ADDENDUM NUMBER ONE

April 30, 2018

New Church Our Lady of the Caves Catholic Church Horse Cave, Kentucky

P0.1

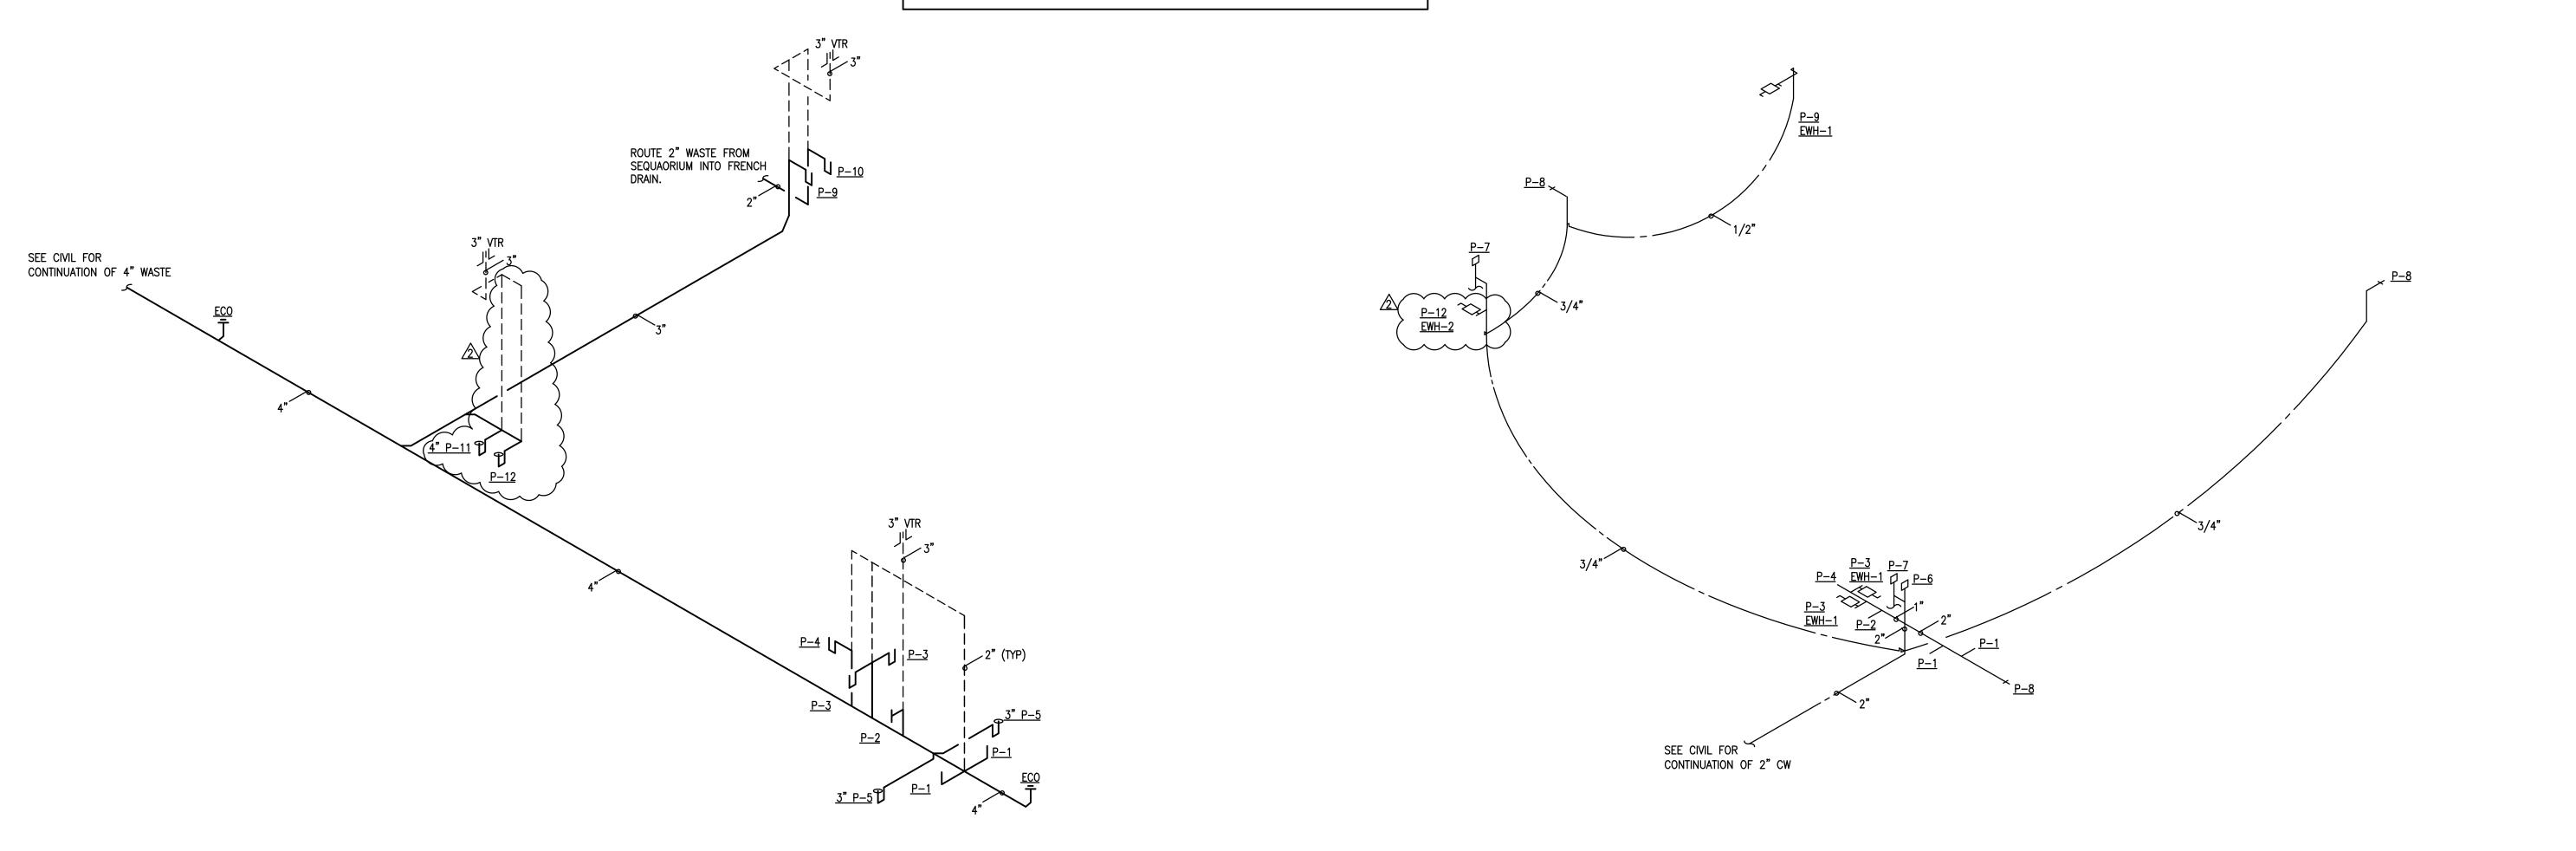
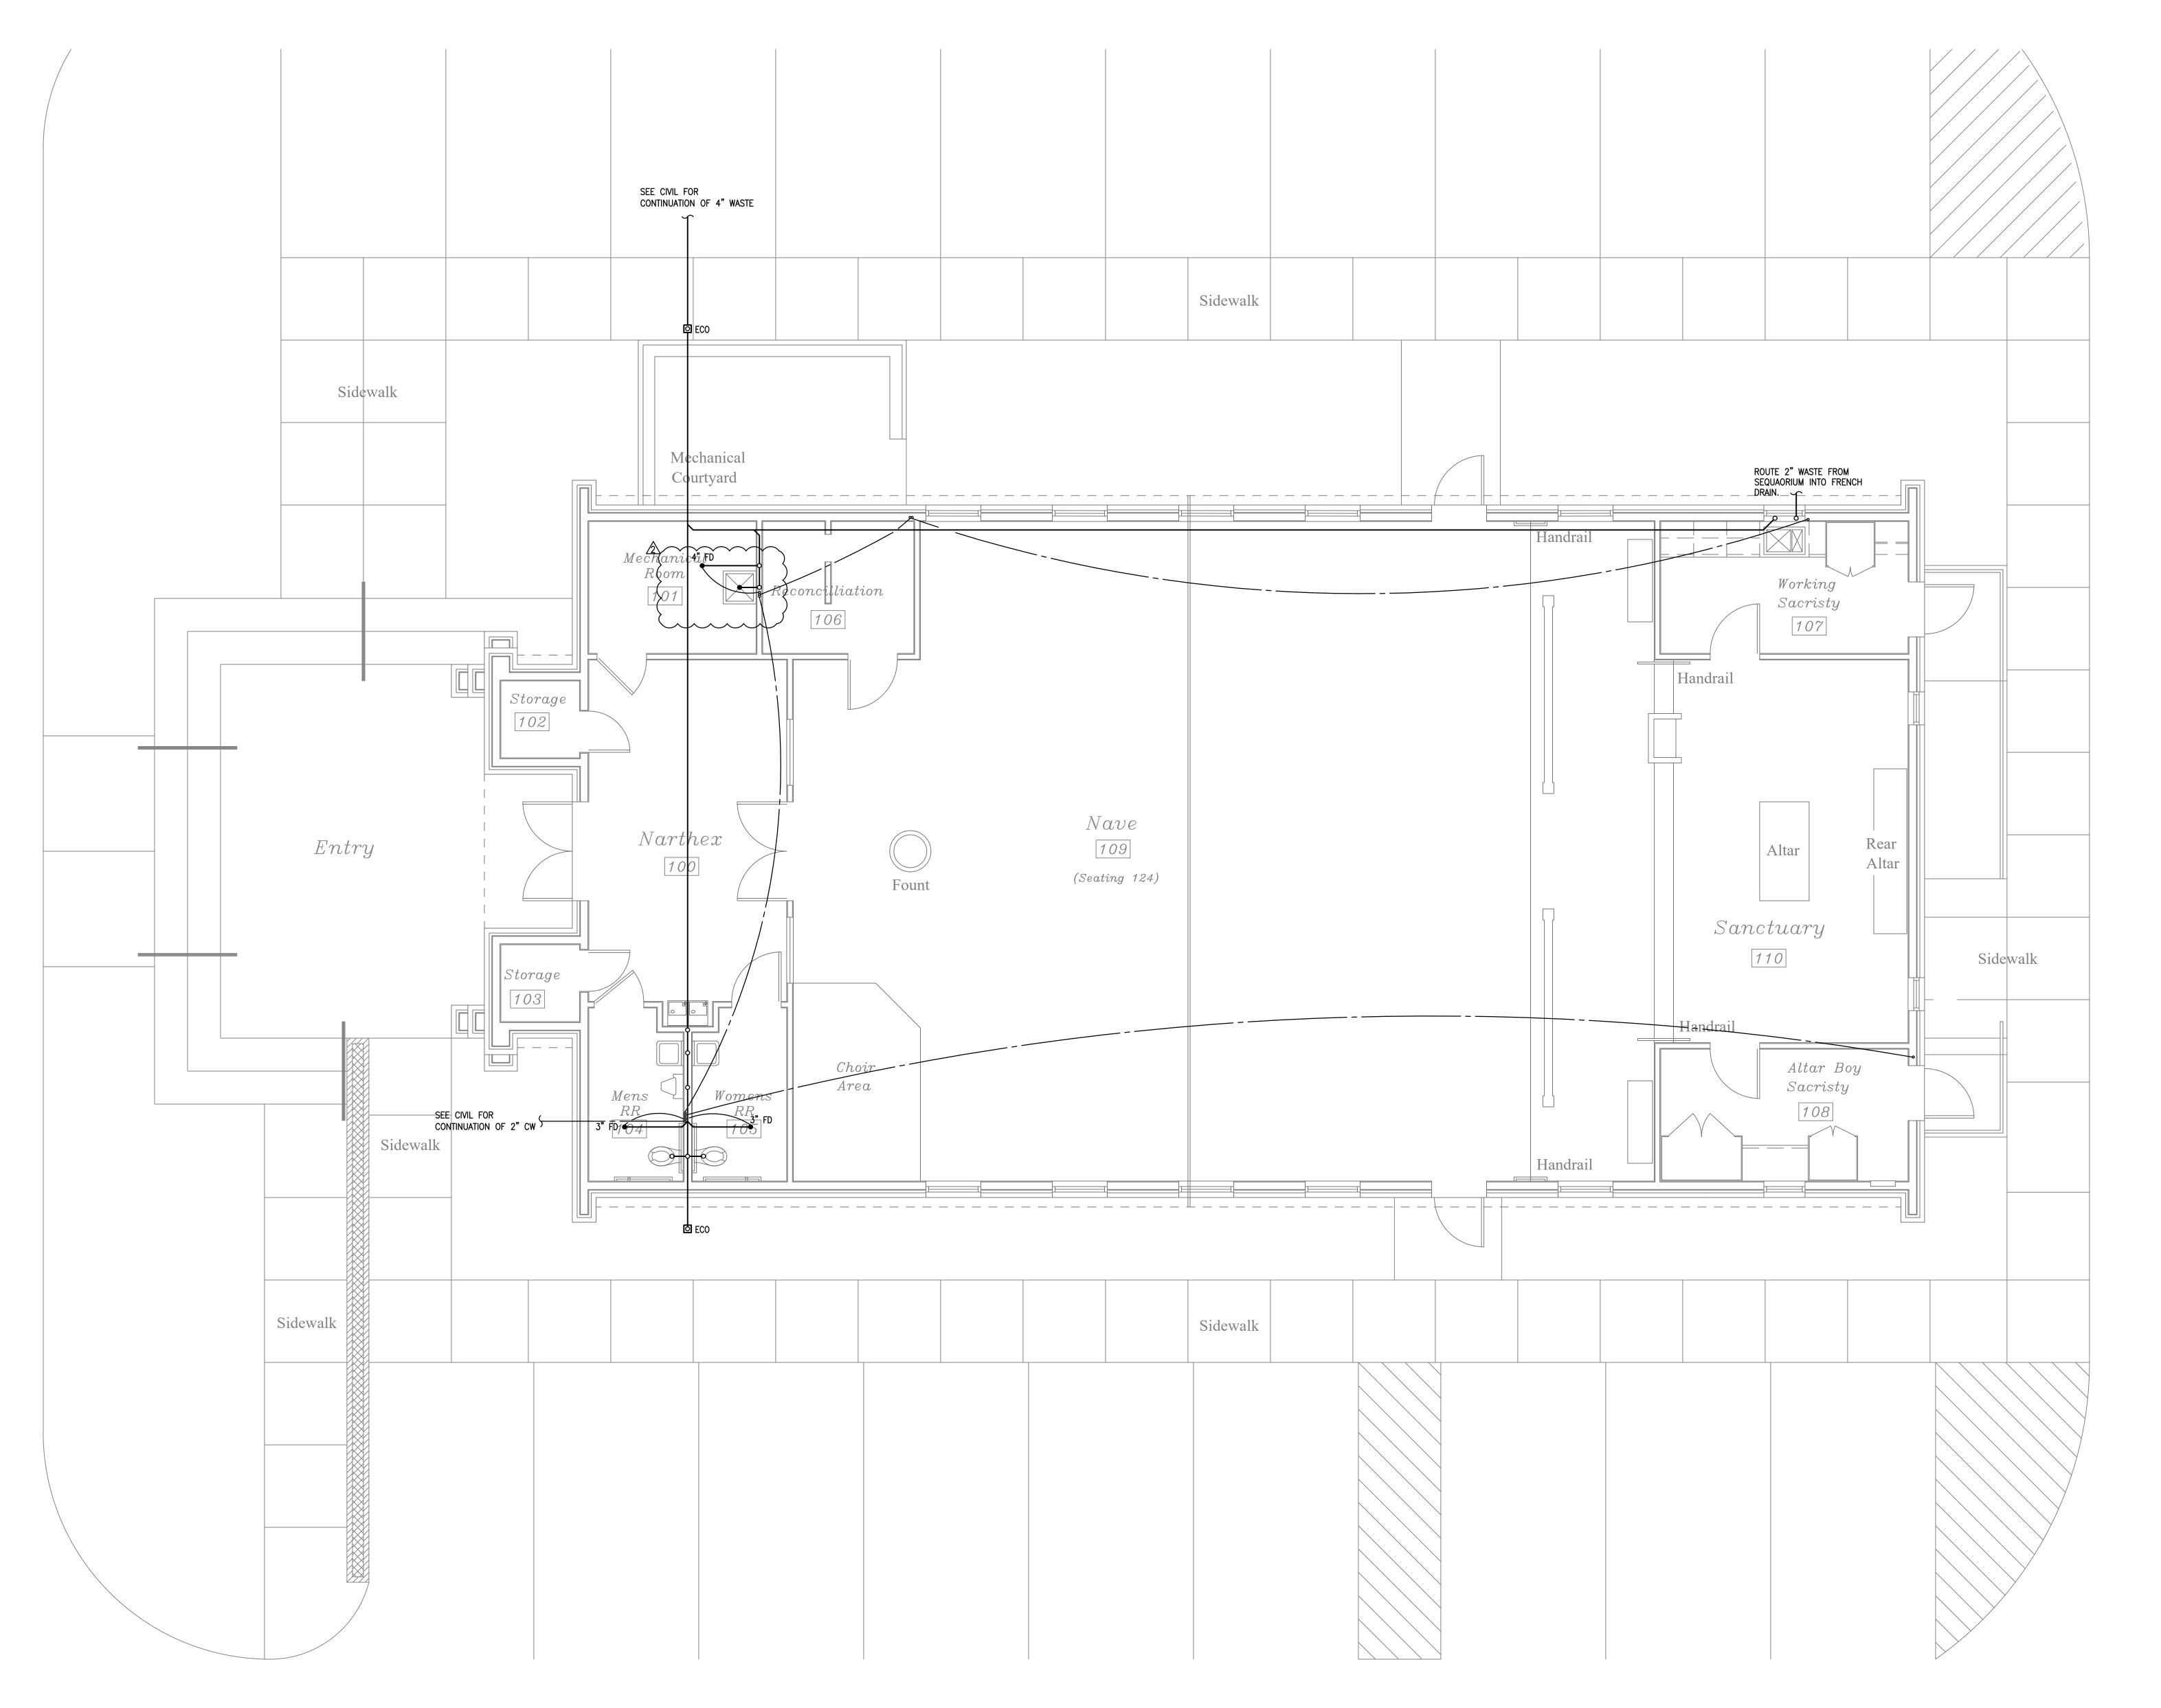
A. See revisions on attached drawing sheets. These drawings indicate the installation of a new mop sink and floor drain to be located in Mechanical Room 101. It also includes the installation of a new on-demand electric water heater and associated venting.

SHEET NO: E3.1

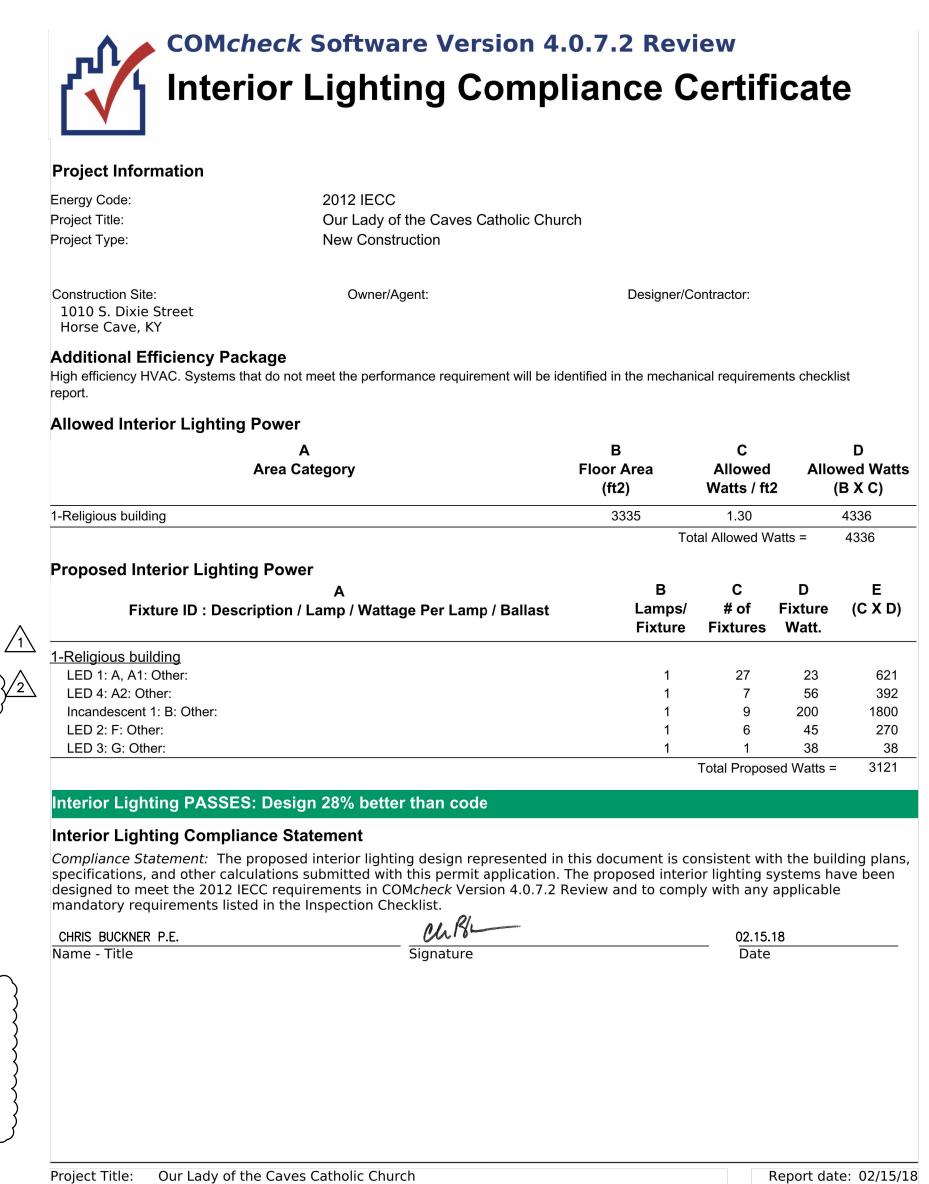
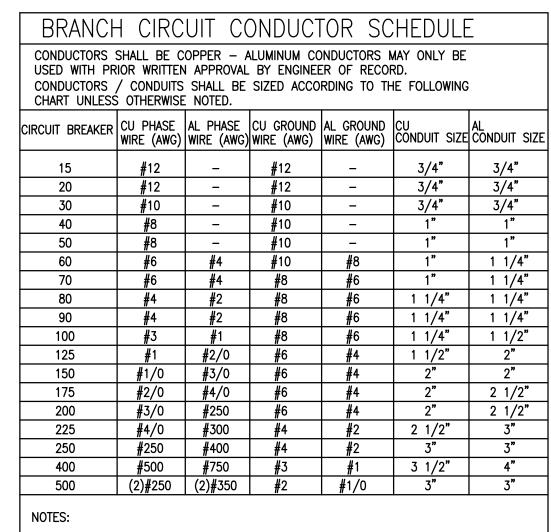
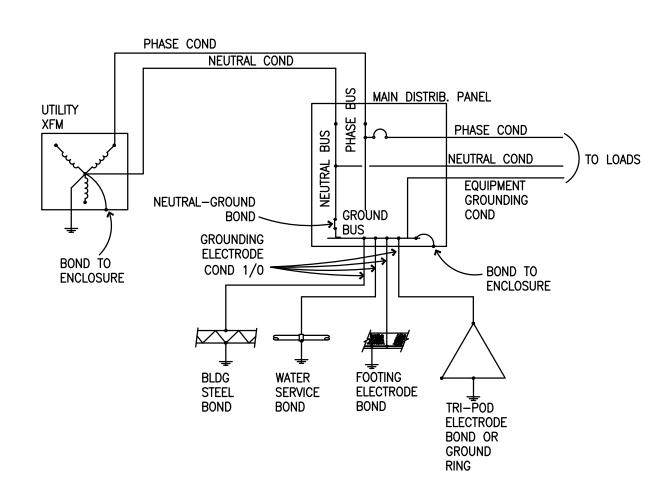
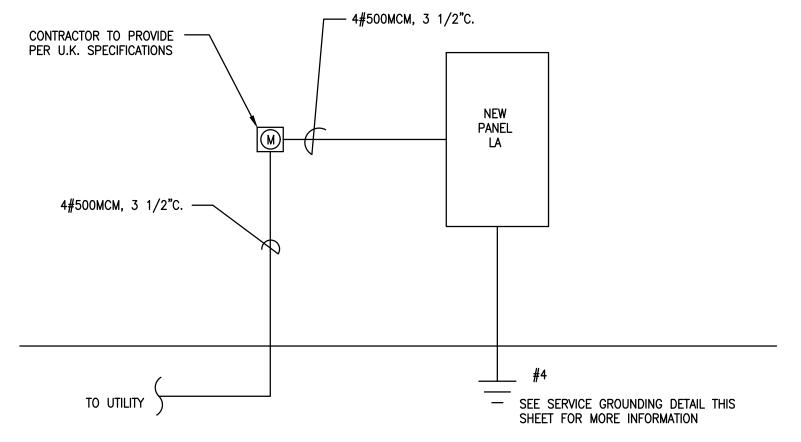
- A. The panel schedule for new panel LA includes a 400/3 Main Circuit Breaker. The buss Amperage on the schedule is also shown as 400 amp. (Note The demand load shown on the panel schedule is 300.4 amps. The demand load is calculated based on diversities listed in the NEC. The service for this building cannot be reduced to a 200 amp service and meet the requirements of NEC for service sizing).
- B. Building Service Grounding Detail The 4 grounding electrodes shown (Bldg. Steel, Water Service Bond, Footing Electrode Bond, Tri-pod Electrode Bond or Ground Ring.) are to be used if available. If the Bldg. steel, metal water line or concrete footing isn't available the driven ground rod (Tri-pod) shall be provided. If any or all of the other electrodes are available they shall be used in addition to the Tri-pod.
